Office Action Summary

Application No. 10/797,255	Applicant(s) ROARTY, BRIAN P.	
Examiner Erin M. Boyd	Art Unit 3663

DETAILED ACTION

Gray French; Figure 1, page 67

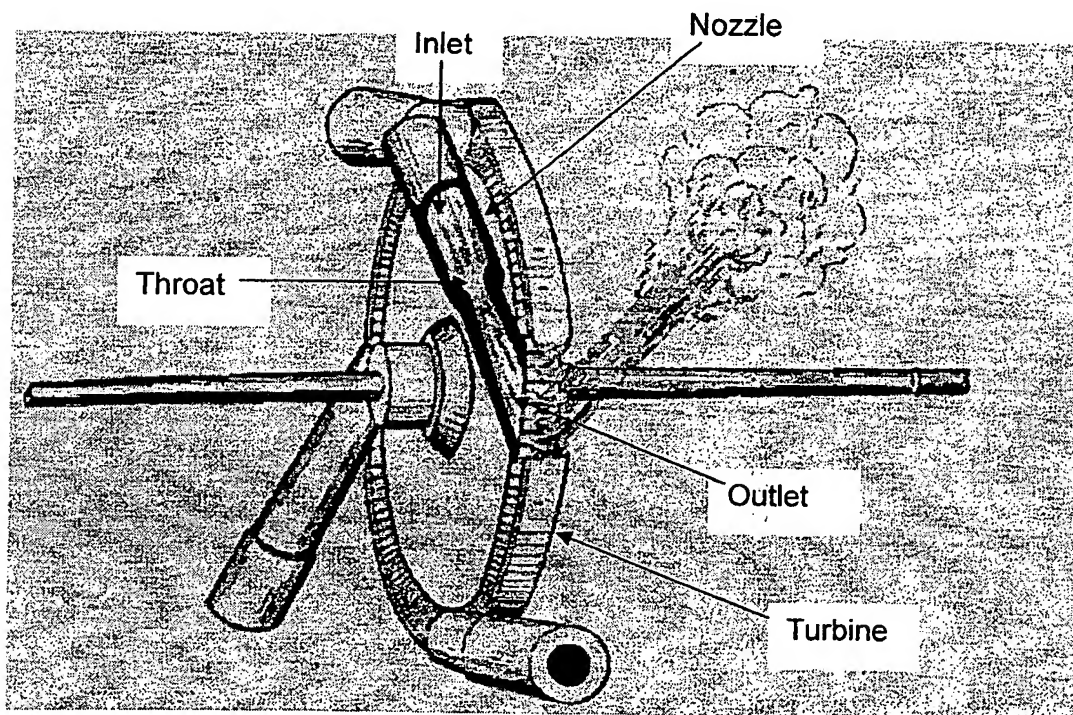
18. Regarding Claim 4, Gray French teaches a system comprising a nozzle having an inlet, a throat, and an exhaust (see figure below); a fluid flowing through the nozzle; and a means (i.e. turbine) for transforming the flow from the exhaust into work outside the system. Gray French fails to teach a means embedded within the nozzle for transferring energy into and heating the nozzle, thereby indirectly transferring energy into and heating the fluid and inducing a phase change in the fluid. Patterson teaches a means 38/44/36 embedded within a nozzle 12 for transferring energy into and heating the nozzle 12 (column 2, lines 15-17); thereby indirectly (through means 36) transferring energy into and heating the fluid and inducing a phase change in the fluid (column 3, lines 59-60).

19. Regarding Claim 5, Gray French teaches a system wherein the cross-sectional interior volume of the inlet, throat, and exhaust of the nozzle vary only across one plane perpendicular to the axis of the fluid flowing through the nozzle (see figure below).
